Subject: RESPONSE TO INITIAL SUBMISSION REVIEW COMMENTS – CONTEXTUAL SITE
PLAN SUBMITTAL (DA-1746-16, #1155579, CASE 2016-6043-00)

The City of Aurora (City) is in the process of upgrading the capacity of the existing Highpointe Lift Station (HLS) due to projected increases to flow resulting from rapid development of the area served by the lift station. Aurora Water is the Applicant for the project and Black & Veatch is acting as the Agent and Engineer of Record. This letter serves as the response to the Initial Submission Review comments that were received on December 21, 2016. These responses follow the numbering of the review letter, and a copy of the letter is included as an attachment.

Re: Initial Submission Review – Highpointe Lift Station Capacity Improvements Project – CSP
Application Number: **DA-1746-16**
Case Number: **2016-6043-00**

TRADITIONAL SOLID MASONRY WALL

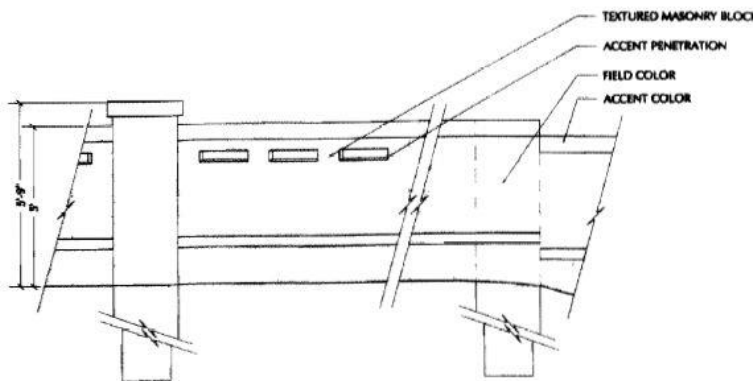
3A. Please revise the proposed masonry fence to match the fence identified in the High Point at DIA Framework Development Plan / what is existing along Dunkirk Street north of 64th Avenue. Below are two images that show what fence is identified in the approved Framework Development Plan and approved Contextual Site Plan, respectively.

Response: Fence style was redesigned to match as closely as possible to the examples provided. The extra height and soil types do not allow the foundation to be the same as the neighboring fences, but the exterior styling will match.
